Subject: Applicant's Response to PVID Comments on Preliminary Staff Assessment
Rio Mesa Solar Electric Generating Facility (11-AFC-4)

RE: TECHNICAL MEMO, BRIGHTSOURCE RESPONSE TO PVID COMMENTS

DATE	21 December 2012
TO	TECHNICAL MEMORANDUM
FROM	Mark Trudell, Ph.D., PG, CHG
COPY	Michael Rojansky
PROJECT NAME	BrightSource Rio Mesa Groundwater Resources Impact Assessment
PROJECT NO.	
SUBJECT	Response to PVID Comments on the Preliminary Staff Assessment
FILE LOC.

GROUNDWATER PUMPING AND RECHARGE
ON THE PALO VERDE MESA

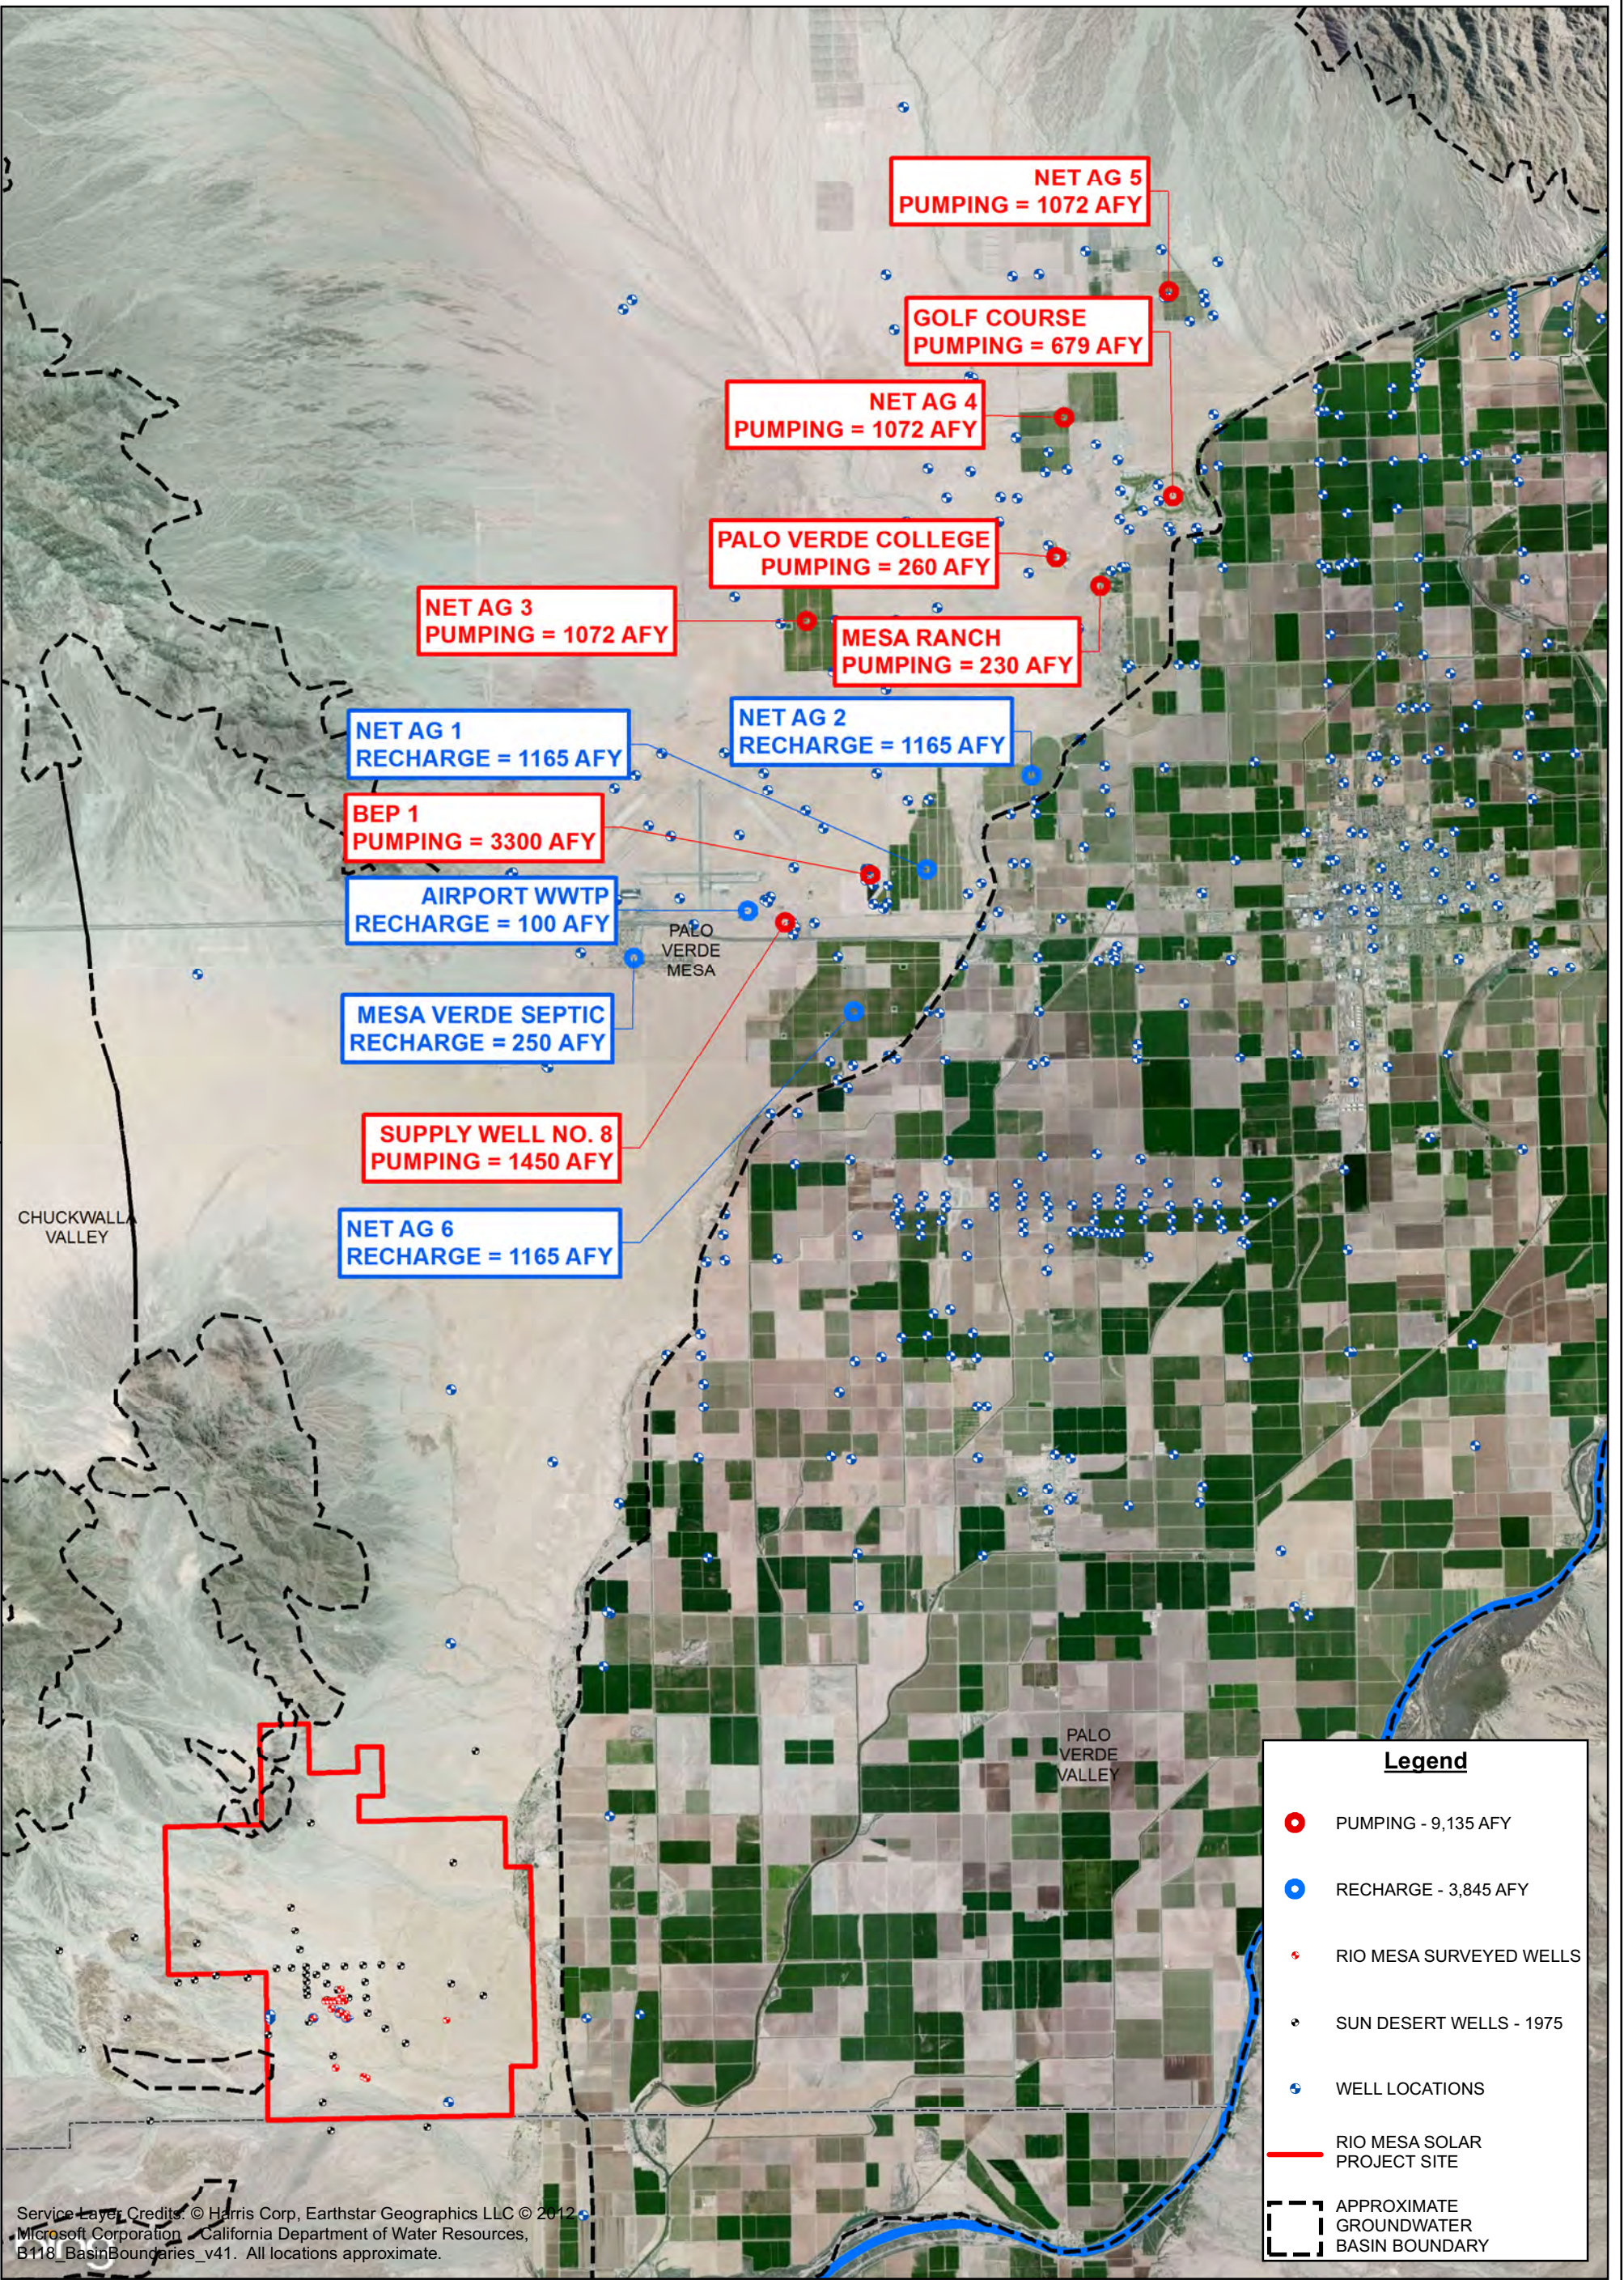
1. Pumping and deep percolation recharge on the Palo Verde Mesa, as described above in the revised RMS water balance, was added to the model. Net agricultural (Ag) pumping or recharge, and other institutional and commercial pumping and deep percolation recharge were added to model, as summarized in Table 3. The location and quantities of these flows are shown in Figure 2. These flows were introduced to the model as steady-state well boundary cells. The net pumping that resulted from this revision reduced heads in the northern part of the Palo Verde Mesa, which required additional adjustment (lowering) of layer 1 bottom elevations in the mountain front areas to avoid dry cells.

Type	Name	AFY
Pumping	Supply Well No. 8	1,450
Pumping	BEP 1	3,300
Pumping	Golf Course	679
Pumping	Mesa Ranch	230
Pumping	Palo Verde College	260
Pumping	Net Ag 3	1,072
Pumping	Net Ag 4	1,072
Pumping	Net Ag 5	1,072
TOTAL PUMPING		9,135
Recharge	Airport WWTP	100
Recharge	Mesa Verde Septic	250
Recharge	Net Ag 1	1,165
Recharge	Net Ag 2	1,165
Recharge	Net Ag 6	1,165
TOTAL RECHARGE		3,845

Note: Refer to Figure 2 for locations of pumping and recharge

RIO MESA SOLAR POWER PROJECT		 WorleyParsons resources & energy		
DRAWDOWN CONTOUR MAP REVISED RMS IMPACT MODEL		SWL	MT	11/2012
		308038-03598		3

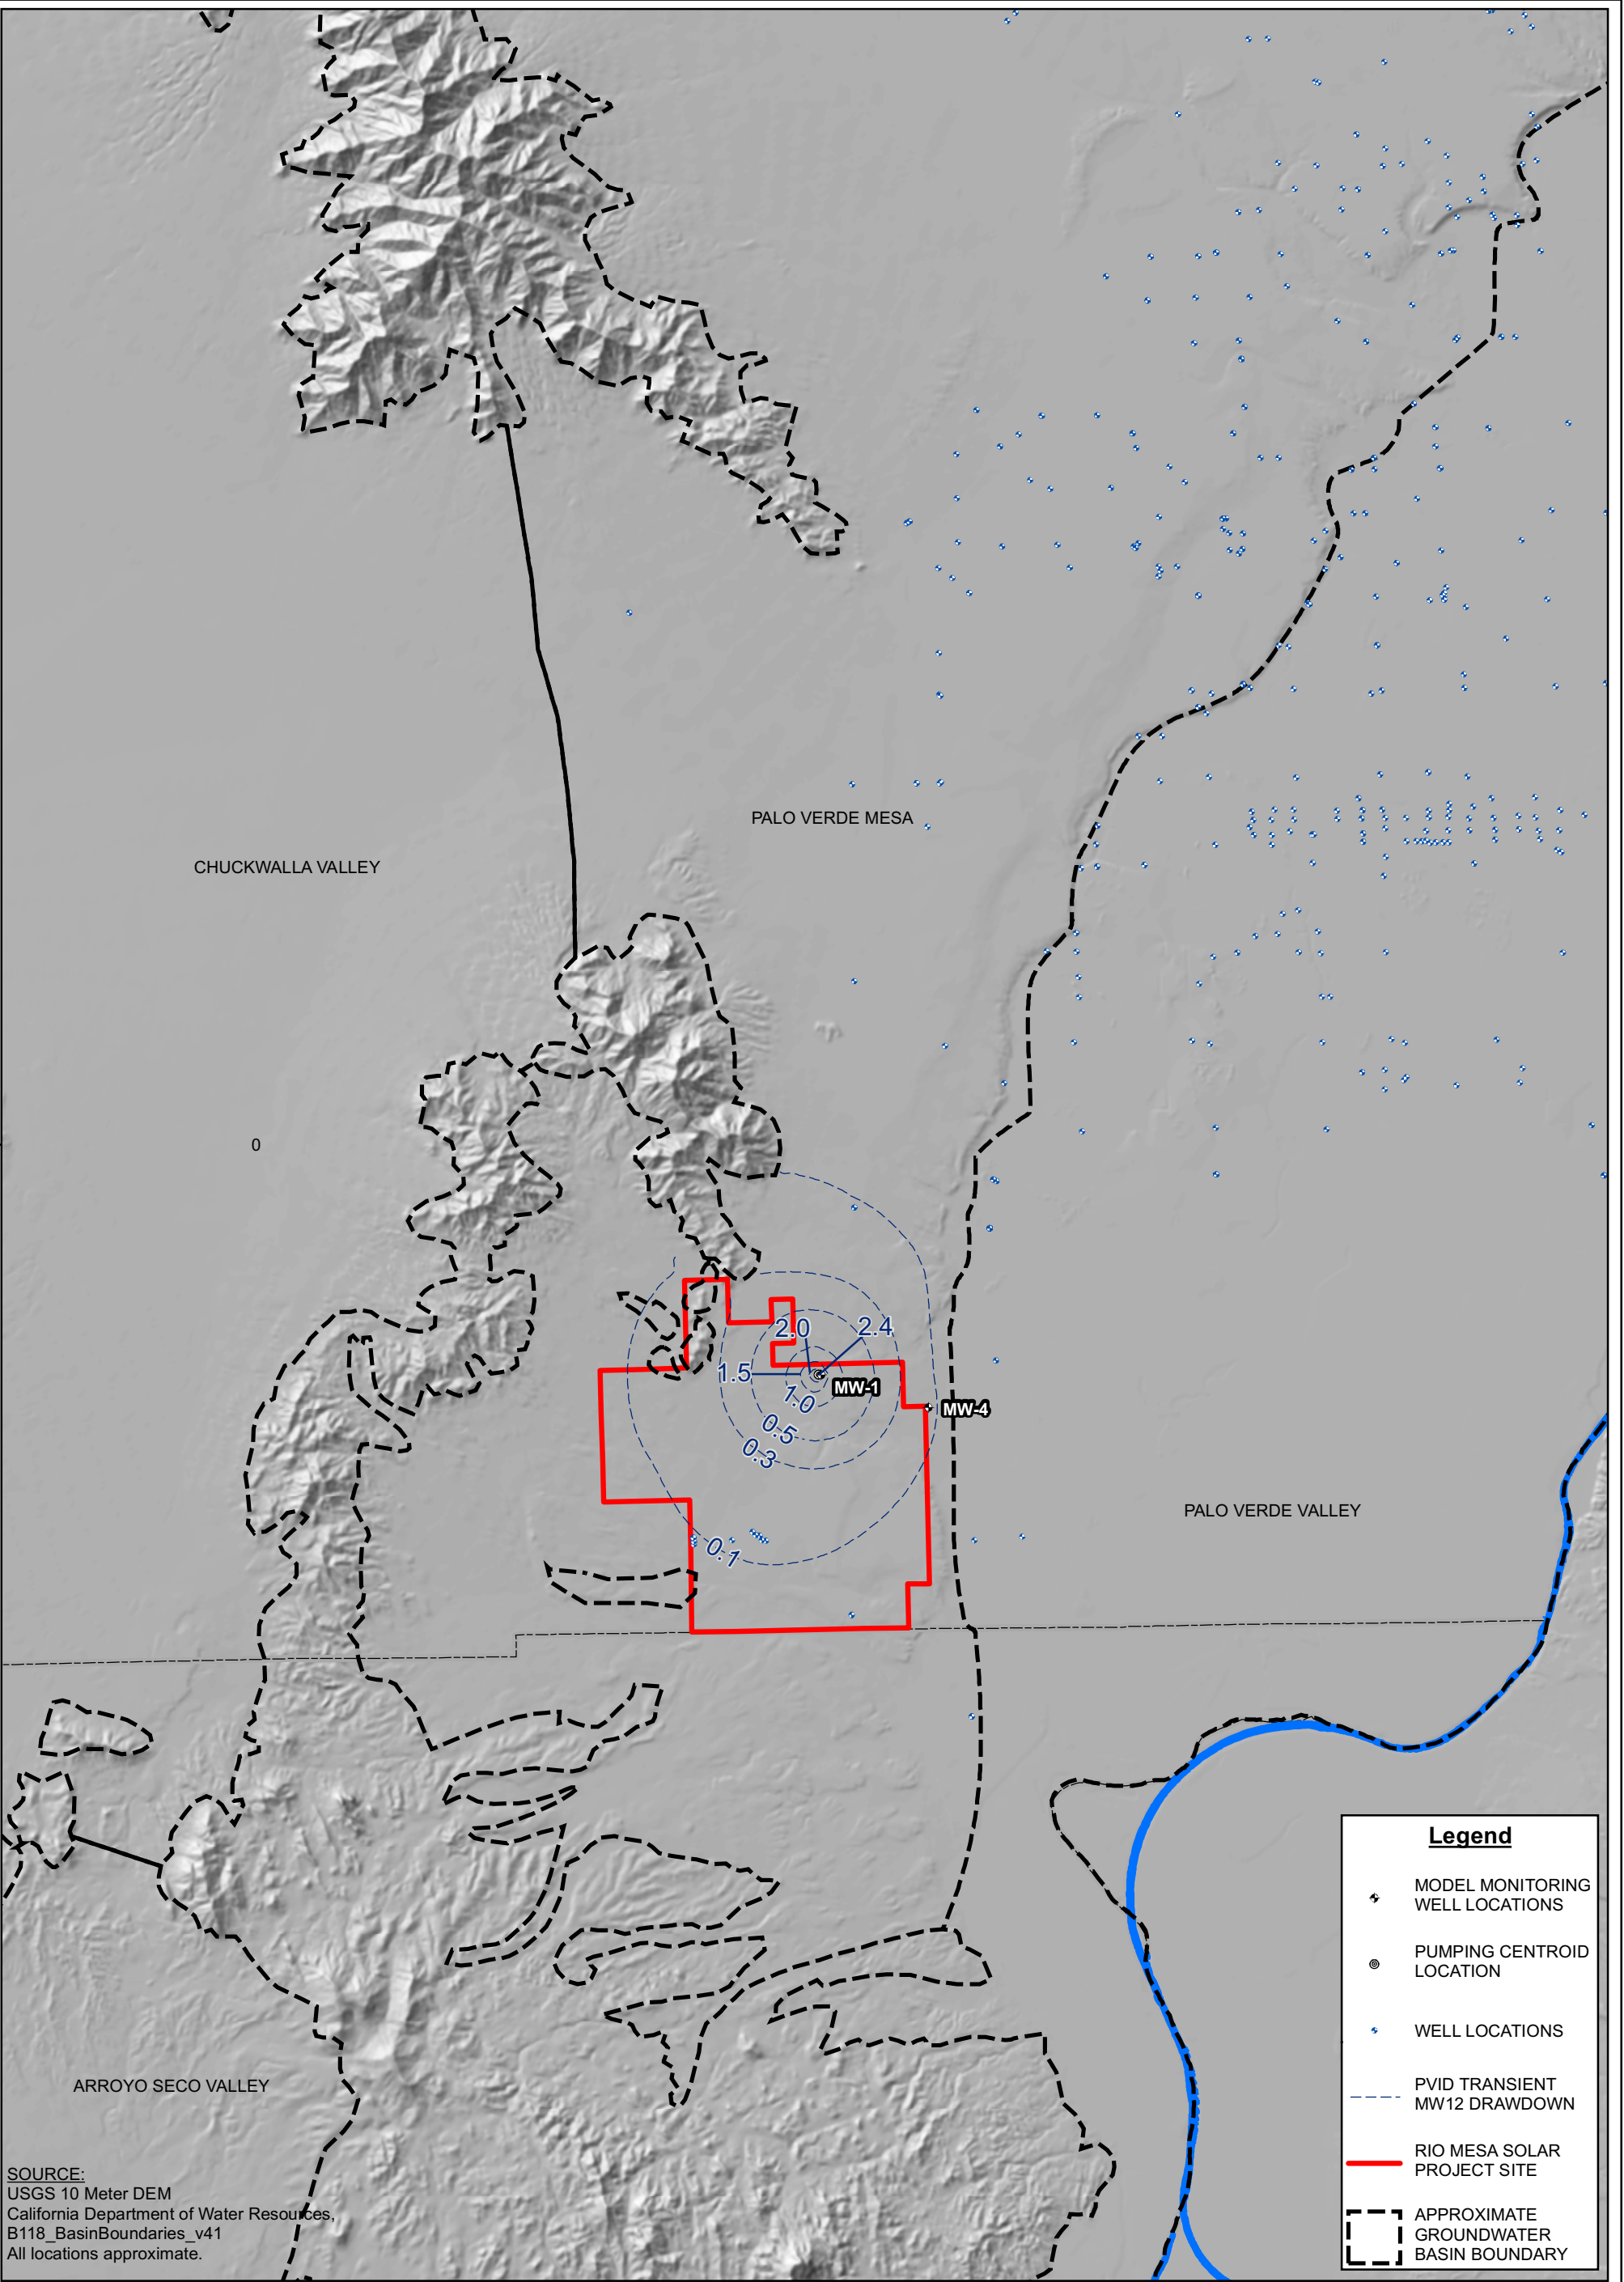
- PVID Comment 3: PVID points out that the functional hydrologic boundary between the Palo Verde Mesa Groundwater Basin (PVMGB) and the Palo Verde Valley Groundwater Basin (PVVGB) coincides with the PVID drains at the foot of the mesa, which act as a drainage divide between two different flow regimes. This observation regarding the way the groundwater flow functions in the area is fundamental to understanding potential project impacts and was described in the hydrogeologic setting description in the AFC groundwater impact analysis. This understanding was also adopted in the groundwater impact modeling conducted for the project. The basin boundaries reported by the California Department of Water Resources were also presented in the AFC for administrative purposes only. While this understanding is also implicit in the PSA, we agree it should be more prominently reflected in the groundwater resource analysis presented in the PSA. The approximate location of this boundary is shown on Figures 2 and 3.

Figure 3 shows the project related drawdown predicted by the Revised RMS model. The model results show that project-related drawdown impacts will be less than significant. Consistent with previous model results provided to the CEC, drawdown decreases rapidly away from the pumping wells in the Revised RMS model and is similar in extent to previous model results. The revised model predicts that the 0.1 ft drawdown contour to the east of the RMS wells will not extend from Palo Verde Mesa Groundwater Basin into the Palo Verde Valley Groundwater Basin.

The maximum predicted drawdown will occur near the pumping wells for the project at the end of construction pumping when operational pumping also start, in first quarter (Q1) 2016, and is predicted to be approximately 9.6 feet. After construction pumping finishes, operational pumping decreases to 173 AFY and groundwater levels near the pumping wells will recover while the overall drawdown cone continues to expand. The maximum lateral extent of predicted drawdown will occur at the end of project operation. At the end of project pumping, the maximum predicted drawdown near the project wells is 3.8 feet in the Revised RMS model. Drawdown is predicted to be less than 1 foot at distances greater than 0.4 mile from the pumping wells at the end of project pumping. Measurable drawdown is not predicted to extend westward beyond the site boundaries. Drawdown beneath the undeveloped land immediately north of the site is predicted to be approximately 2 feet near the site boundary and decreasing rapidly northward to 0.3 feet or less at a distance of about 1 mile from the site.

HYDROGRAPHS OF SIMULATED CLOSE MONITORING WELL
AND MONITORING WELL MW-4

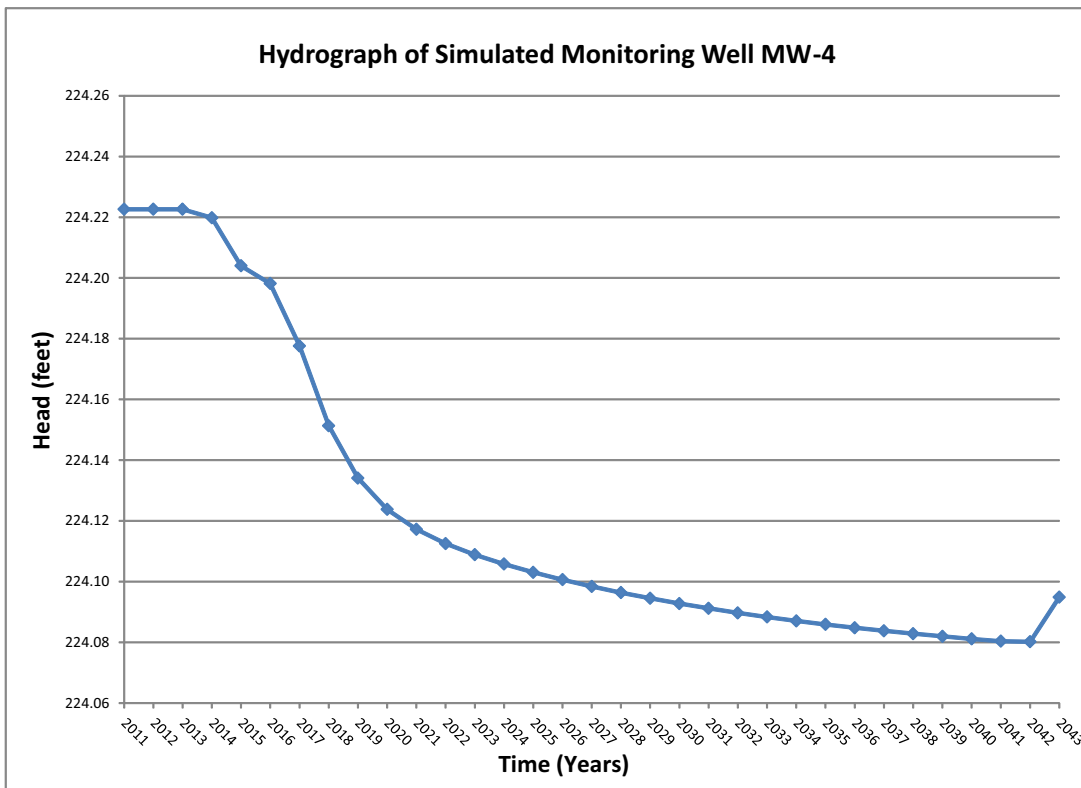
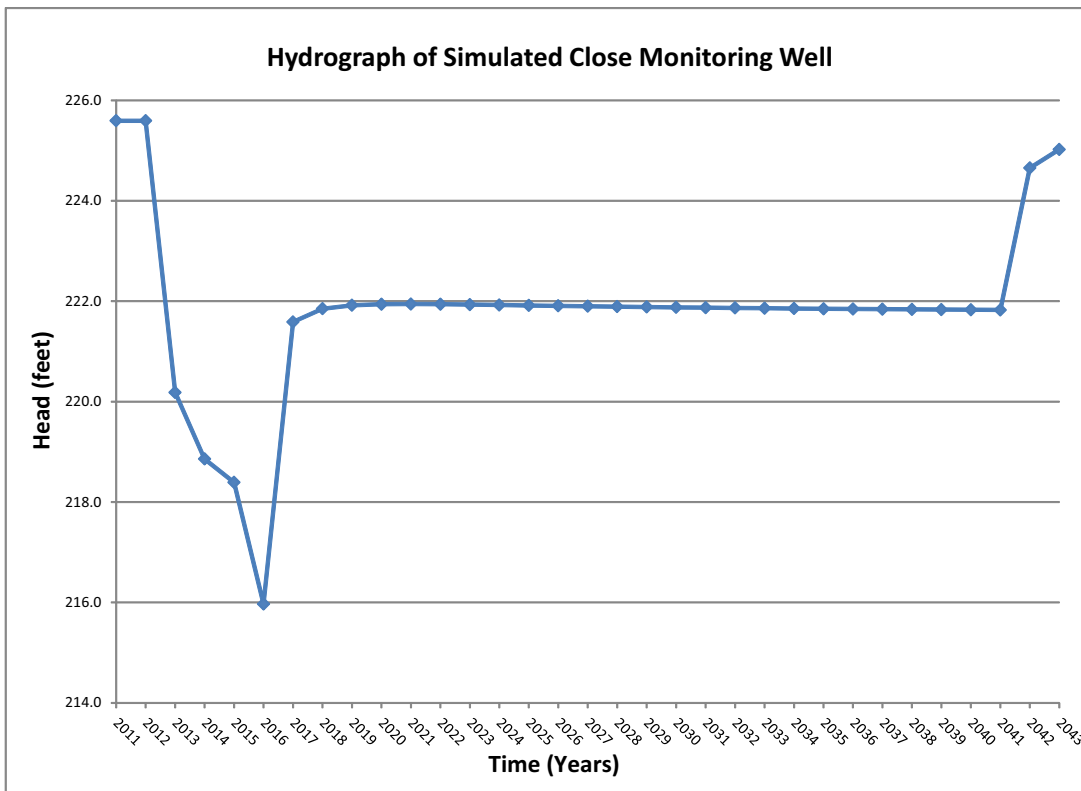
Figure 4 compares the groundwater level versus time at simulated monitoring well MW-1 in the cell adjacent to the pumping centroid. The drawdown response at MW-1 is very similar to previous model simulations. The maximum predicted drawdown at simulated monitoring well MW-4, located near the PVID drain at the edge of the mesa, is 0.14 feet in the Revised RMS model, similar to previous RMS models.
